Access Compliance Report

Public Rights-of-Way

(Curb Ramps)

Intersection ID: 42370	Main Street: BENTGRASS_RUN_DR	Cross Street: WHISTLER'S_CHASE_DR	Location: E
ADA ID: BE112ECCEF69	Ramp Type: PerpDiag	Initial Pass/Fail: Fail	Overall Compliance: No
		Severity Score: 22.5

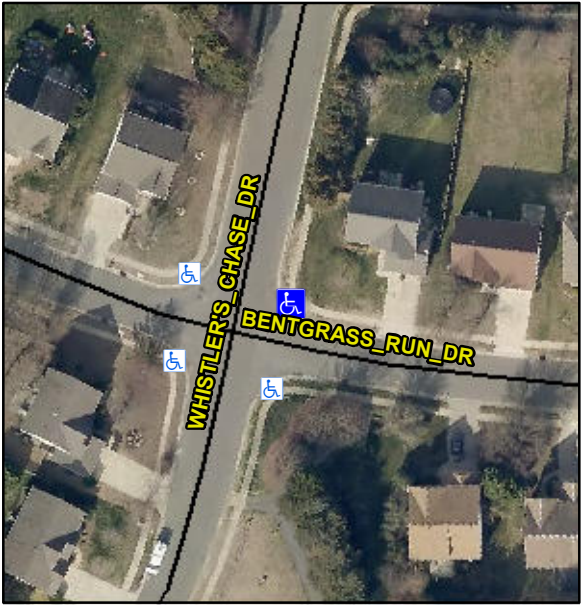
Codes/Mitigation Info/Possible Solution			Field Measurements/Component Compliance		
	Possible Solutions:		Compliance	Description	Data
	Remove & Replace Curb Ramp With Two New Directional Ramps or Equivalent.		No	Ramp Length (in)	49.0
			No	Ramp Width (in)	41.0
			N/A	Flare Type LT	N/A
			N/A	Flare Slope LT (%)	N/A
			N/A	Flare Traversable LT?	N/A
			N/A	Landing Length (in)	N/A
			N/A	Landing Width (in)	N/A
			N/A	Landing Slope (%)	N/A
			N/A	Landing X Slope (%)	N/A
<p>Surveyor Notes:</p> <p>N/A</p> <p>PROW/ADA:</p> <p>Not Found, R304.5.1, R304.2.2, R304.5.3</p>			N/A	Flare Type RT	N/A
			N/A	Flare Slope RT (%)	N/A
			N/A	Flare Traversable RT?	N/A
			N/A	DWS Provided?	N/A
			N/A	DWS Contrast?	N/A
			N/A	DWS Length (in)	N/A
			N/A	DWS Full Width?	N/A
			N/A	DWS Offset (in)	N/A
			N/A	Shared Landing?	N/A
			N/A	Gutter Ponding?	N/A
			N/A	Gutter Lip Ht (in)	N/A
			N/A	Painted X Walk1?	No
				X Walk 1 Direction	To NW

N/A	X Walk 1 Width (in)	N/A
				X Walk 1 Slope (%)	2.0
				X Walk 1 X Slope (%)	0.5
			N/A	Ramp inside XWalk1?	N/A
				Road Slope (%)	3.7
				Road X Slope (%)	0.4
			N/A	Any Obstructions?	N/A
				Obstruction Type	
Total Cost:		\$ 3200.00
